UNITED STATES PATENT AND TRADEMARK OFFICE

APPLICATION NO. FILING DATE FIRST NAMED INVENTOR ATTORNEY DOCKET NO. CONFIRMATION NO. 10/789,388 02/28/2004 John P. Kallestad DC1-001 4950 01/27/2006 **EXAMINER** Brian C. Kelly, Ltd. KAYES, SEAN PHILLIP Attorney at Law ART UNIT PAPER NUMBER 555 South Center St. Reno, NV 89501 2841 DATE MAILED: 01/27/2006

Application No.	Applicant(s)		
	10/789,388	KALLESTAD, JOHN P. (A)		
Office Action Summary	Examiner	Art Unit		
	Sean Kayes	2841		
The MAILING DATE of this communication app Period for Reply	pears on the cover sheet with the o	correspondence address		
A SHORTENED STATUTORY PERIOD FOR REPLY WHICHEVER IS LONGER, FROM THE MAILING D. - Extensions of time may be available under the provisions of 37 CFR 1.1 after SIX (6) MONTHS from the mailing date of this communication. - If NO period for reply is specified above, the maximum statutory period or Failure to reply within the set or extended period for reply will, by statute Any reply received by the Office later than three months after the mailing earned patent term adjustment. See 37 CFR 1.704(b).	ATE OF THIS COMMUNICATION 36(a). In no event, however, may a reply be ting will apply and will exp

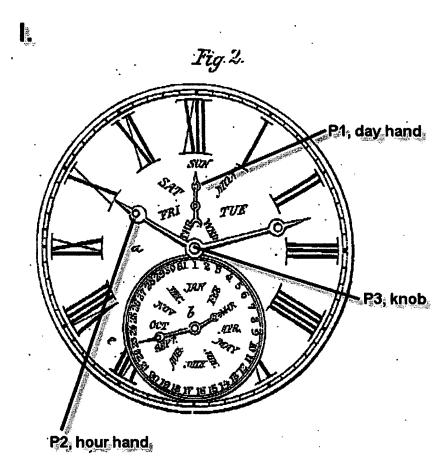
- (b) the invention was patented or described in a printed publication in this or a foreign country or in public use or on sale in this country, more than one year prior to the date of application for patent in the United States.
- 4. Claims 1-4 and 7-9 are rejected under 35 U.S.C. 102(b) as being anticipated by Carter (US 39883.)
- 5. With respect to claim 1 Carter discloses a clock comprising means for actuating a hand to indicate day of the week (the driving means behind the movement of P1, picture I, shown in figure 1 as item C.)

- 6. With respect to claim 2 Carter discloses a clock as described in claim 1 wherein said means for actuating said hand (P1) comprises at least one gear (see figure 1) having a rotation cycle of 7 days.
- 7. With respect to claim 3 Carter discloses a clock as described in claim 2 wherein said gear communicates with at least one other gear (gear connected to hand P2) that completes 14 revolutions in said cycle.
- 8. With respect to claim 4 Carter discloses a clock as described in claim 3 wherein said other gear actuates at least one hand (P2) to indicate hours.

- 9. With respect to claim 7 Carter discloses a clock as described in claim 1 further comprising means for adjusting time indicated by said clock (a means for adjusting time indicated by a clock is implied.)

- 10. With respect to claim 8 Carter discloses a clock as described in claim 1 wherein said adjustment means comprises at least one knob (the time can be adjusted by rotating the displayed hand about the knob P3, picture I.)

- 11. With respect to claim 9 Carter discloses a clock as described in claim 1 wherein said adjustment means comprises at least one knob to adjust said day indicator (the hour hand, P2, is connected to the day hand, P1, and rotating the hour hand to adjust the time would in turn rotate and adjust the day hand, P1.)

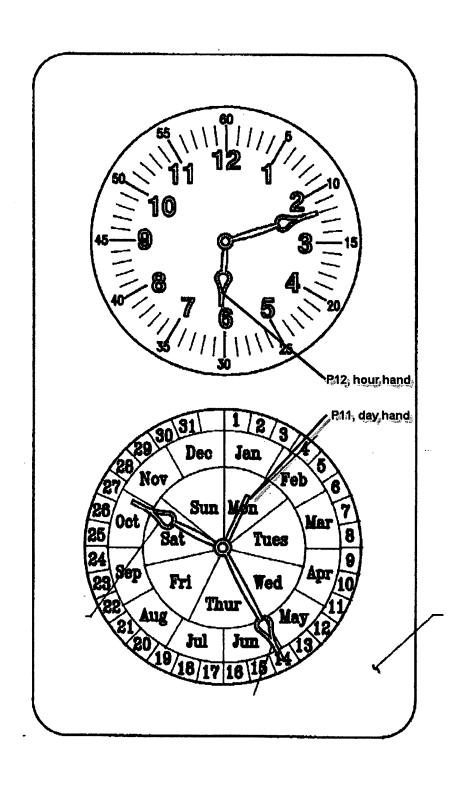
- 12. Claims 1-9 are rejected under 35 U.S.C. 102(b) as being anticipated by Evans (US 6359840.)
- 13. With respect to claim 1 Evans discloses a clock comprising means for actuating a hand (P11, picture II.) to indicate day of the week.

- 14. With respect to claim 2 Evans discloses a clock as described in claim 1 wherein said means for actuating said hand comprises at least one gear having a rotation cycle of 7 days (the gear that drives P11.)

- 15. With respect to claim 3 Evans discloses a clock as described in claim 2 wherein said gear communicates with at least one other gear that completes 14 revolutions in said cycle (the gear that drives P12.)

- 16. With respect to claim 4 Evans discloses a clock as described in claim 3 wherein said other gear actuates at least one hand to indicate hours (P12.)

- 19. With respect to claim 7 Evans discloses a clock as described in claim 1 further comprising means for adjusting time (item 36, figure 6) indicated by said clock.

- 20. With respect to claim 8 Evans discloses a clock as described in claim 1 wherein said adjustment means comprises at least one knob (item 36 figure 6.)

- 21. With respect to claim 9 Evans discloses a clock as described in claim 1 wherein said adjustment means comprises at least one knob (36 figure 6) to adjust said day indicator.

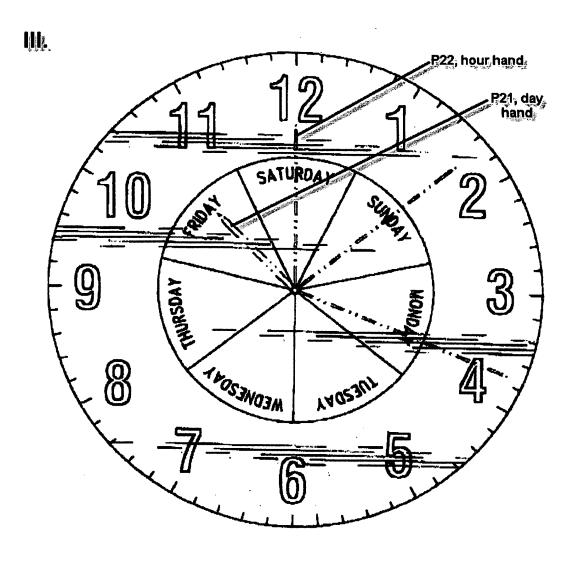
- 22. Claims 1-4 are rejected under 35 U.S.C. 102(b) as being anticipated by Kallestad (US D458566.)

- 23. With respect to claim 1 Kallestad discloses a clock comprising means for actuating a hand (P21, picture III.) to indicate day of the week.
- 24. With respect to claim 2 Kallestad discloses a clock as described in claim 1 wherein said means for actuating said hand comprises at least one gear having a rotation cycle of 7 days (the gear that drives P21.)
- 25. With respect to claim 3 Kallestad discloses a clock as described in claim 2 wherein said gear communicates with at least one other gear that completes 14 revolutions in said cycle (the gear that drives P22.)
- 26. With respect to claim 4 Kallestad discloses a clock as described in claim 3 wherein said other gear actuates at least one hand to indicate hours (P22.)
